Re: LC 73 – Portland General Electric Company's 2019 Integrated Resource Plan (IRP)

DOCKET NO. LC 73

**PORTLAND GENERAL ELECTRIC
COMPANY's**

REPLY COMMENTS

Figure 5: IRP Figure 7-13, highlighting relevant portfolios

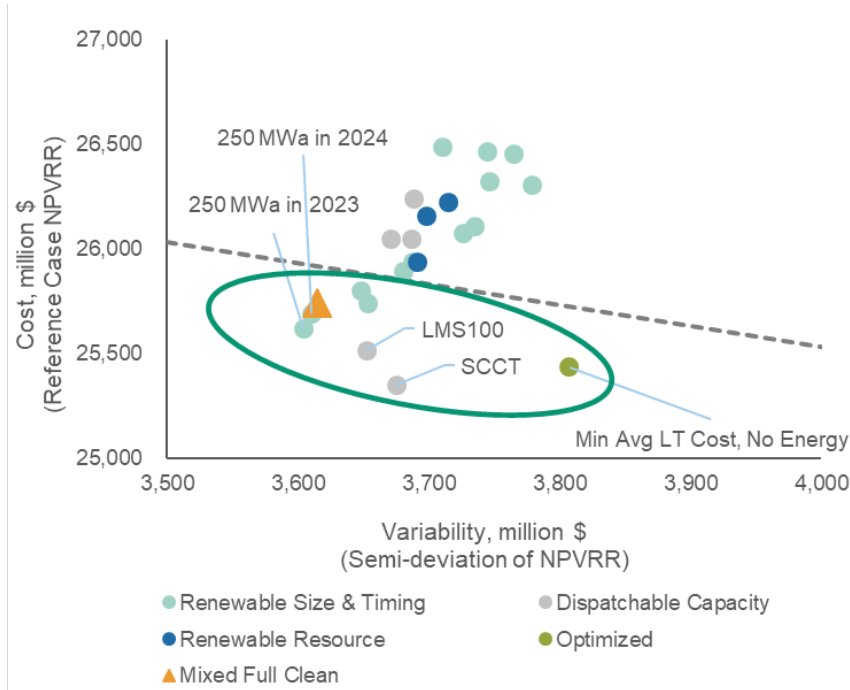
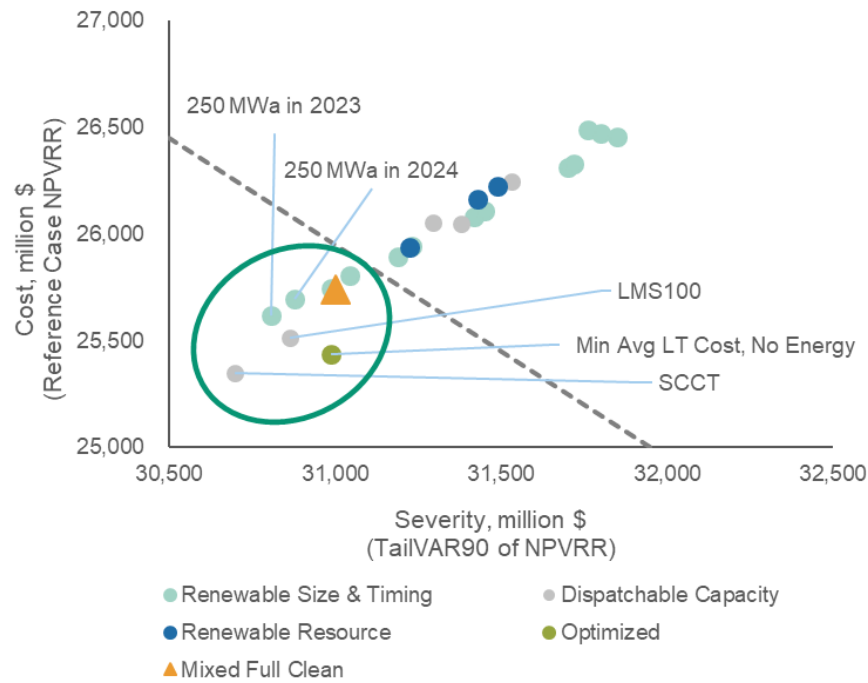
Staff questioned the performance of the preferred portfolio, stating its construction was "somewhat puzzling, and may present another blunt instrument in portfolio selection. Staff finds this approach particularly curious given that the Mixed Clean Full (sic) is outperformed by others in terms of cost and risk, as shown by PGE's graphics."⁵⁸

Staff's comments regarding preferred portfolio performance refer to IRP Figures 7-13 and 7-14, which display the preferred portfolio's performance of cost/risk measures relative to other portfolios not screened by the non-traditional metrics. Similar to **Figure 3** and **Figure 4** above, when plotting cost and risk metrics, any movement among portfolios both down and left represent a universal improvement and moving either down and right or up and left represents a trade-off between cost and risk. Staff's concern seems to come from the existence of portfolios down and to the left of the preferred portfolio. It is instructive to examine both figures closer. In **Figure 5** and **Figure 6** below, these IRP graphics are replicated, with relevant individual portfolios highlighted.

While the LMS 100, Min Avg LT Cost, No Energy, and SCCT portfolios outperform the preferred portfolio in terms of cost versus severity, they do not in terms of cost versus variability. Each of these portfolios increase the variability metric relative to the preferred portfolio. Only the renewable size and timing portfolios (250 MWa in 2023 and 250 MWa in 2024) uniformly decrease cost and risk across both variability and severity metrics. In other words, the only way to uniformly reduce cost and risk relative to the preferred portfolio is to add more renewables. However, as discussed above, the preferred portfolio was limited to a 150 MWa addition between 2023-2024 to allow for additional flexibility should other activities bring energy to PGE's portfolio. While allowing additional renewables could result in lower cost and risk scores, PGE believes that limiting the size of the renewable addition provides for future flexibility and mitigates potential unquantifiable risks and does so without significantly impacting the cost and risk performance of the preferred portfolio relative to the best performing portfolios.

Figure 7: Cost associated with renewable addition, by size and COD

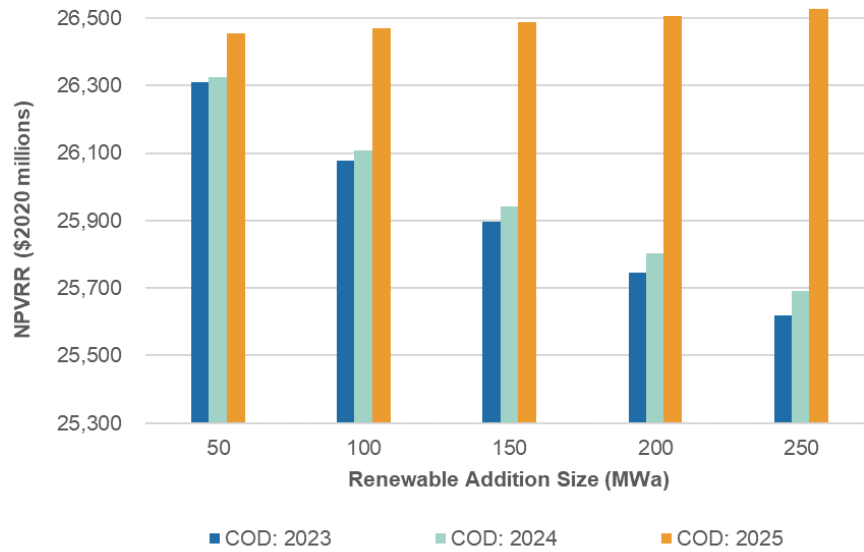
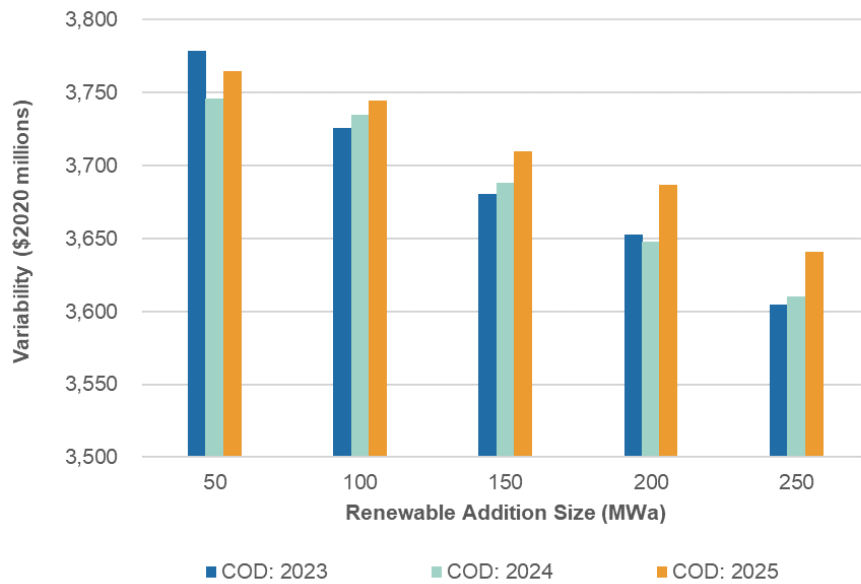
Staff raised concerns about the benefits derived from PGE's proposed Renewable Action in 2020, stating "the cost and risk metrics for renewable size and timing portfolios because the portfolios that add 50 - 250 MWa in 2024 appear similar under the cost metric to the performance of the renewable size and timing portfolios that add 50 - 250 MWa of renewables in 2023."⁶³ Further, Staff stated they seek to understand "the costs and risks of rushing to acquire resource with a COD of 2023."⁶⁴

Comparing the NPVRR of Renewable Size and Timing portfolios, there is a \$16-73 million cost savings associated with a 2023 versus 2024 COD, increasing with the size of the renewable addition. This is displayed below in **Figure 7** and **Figure 8**. **Figure 7** suggests a total system NPVRR decrease associated with adding larger quantity of renewables, unless that action is delayed until 2025. Below, **Figure 8** demonstrates a decrease in variability associated with increasing size, and a changing relationship between CODs: a COD of 2025 shows the slowest decline when adding size, while the CODs of 2023 and 2024 vary depending on renewable addition size.

A significant portion of this value is attributable to the reduction in PTC credits for resources with an earlier COD. As shown in **Table 1** below, this depends on the size of the addition, but remains an important driver in the cost savings associated with early action.

Figure 9: Preferred portfolio composition in changing wind capacity factor sensitivities (MWa)

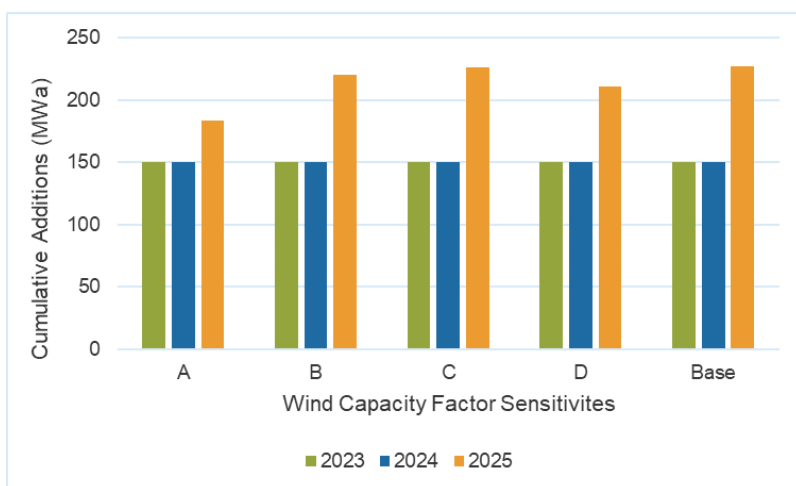
Staff and AWEC both commented on the capacity factors used in PGE's portfolio analysis. AWEC stated "none of PGE's wind resources currently operate at a 40 percent capacity factor and so PGE is likely optimistic about the new wind resource operating capability."⁶⁵ Staff raised concerns about the impact of capacity factor assumptions, and questioned "whether the Company's sensitivity analysis should have been performed on the Mixed Full Clean portfolio to help characterize the risk of acquiring near-term wind assets based primarily on economic performance."⁶⁶

PGE agrees with Staff that the economics of wind resources are an important consideration in this IRP, as many portfolios add significant wind capacity through 2050. To test how changing capacity factors affect the preferred portfolio in response to Staff's Recommendation 20, PGE ran a sensitivity where capacity factors of wind resources are reduced proportionally to the capacity factors used in the capacity factor sensitivity from Section 6.5 – Capacity Factor Sensitivities.⁶⁸ **Table 2** shows these reductions.

The results from the capacity factor sensitivity suggests the renewable resource addition made in 2023 and 2024 in the preferred portfolio are robust and do not change based on significant differences in capacity factors. As shown below in **Figure 9**, the cumulative size of MWa additions in these years remain consistent across capacity factor sensitivities.

Figure 9: Histogram describing distribution of NPVRR normalized to average for Base Case and Colstrip Sensitivity A

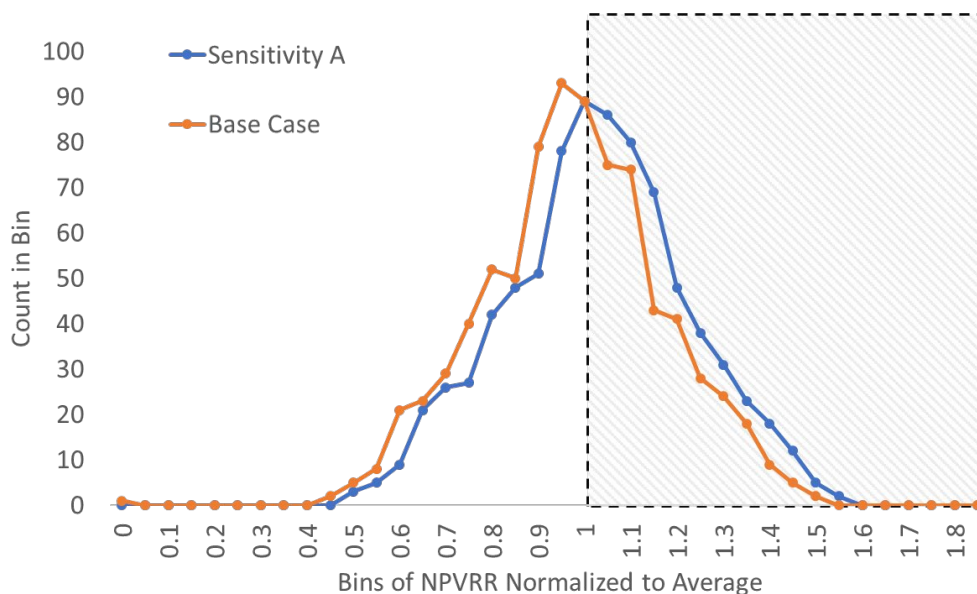
In response to Staff's question regarding the variability metric in the Colstrip sensitivity analysis, PGE provides the following additional information. Under Sensitivity A in which Colstrip is fully depreciated and exits PGE's portfolio by the end of 2027, the energy and capacity required as a result of Colstrip's exit from 2028 to 2034 is solved for by the portfolio optimization.

Figure 9 below depicts histograms that show the distribution of NPVRR normalized to the average over all price futures for the Base Case and for Sensitivity A. Normalizing the NPVRR to the average for Sensitivity A and Base Case allow comparison of the NPVRR distributions. Since Sensitivity A results in additional years of market exposure relative to the non-Sensitivity future, Sensitivity A's corresponding normalized NPVRR distribution is shifted to the right relative to the Base Case and has a larger upper tail. This shift is reflected in the variability portfolio metric, which is the semi-deviation of NPVRR through 2050 across futures, relative to the Base Case. The variability metric is slightly higher for Sensitivity A compared to the Base Case as seen in Table 7-10 of the 2019 IRP.

Figure 13: Energy position distribution compared to renewable energy action with voluntary program sensitivity

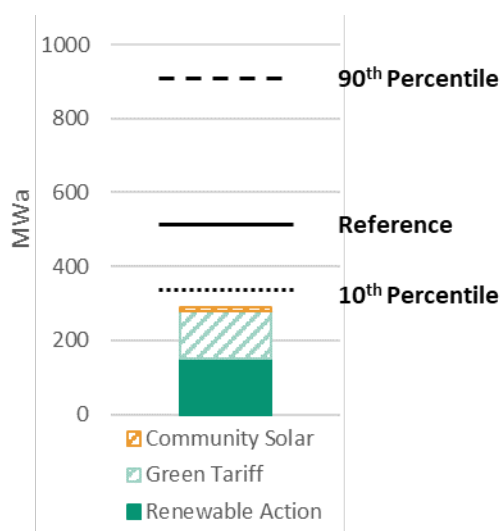
As noted above, some parties expressed concern about the Renewable Action due in part to how the energy position might be changed by voluntary renewable programs. In Section 4.7.2 of the 2019 IRP, PGE provided analysis of the potential energy impacts from three sensitivities regarding voluntary programs, including a sensitivity (Sensitivity C) which assumed 93 MW of Community Solar resources (the full first tier, approximately 12 MWa) and 300 MW of Green Tariff resources (approved cap, approximately 129 MWa). **Figure 13** compares the energy position (Reference, 10th percentile, and 90th percentile) to the energy from the Renewable Action plus the voluntary program energy from Sensitivity C. The total additional renewable energy (approximately 291 MWa), is less than the 10th percentile of the energy position and 224 MWa less than the Reference Case.

As noted previously, PGE plans to provide an update to its need assessments and sensitivities in November 2019.
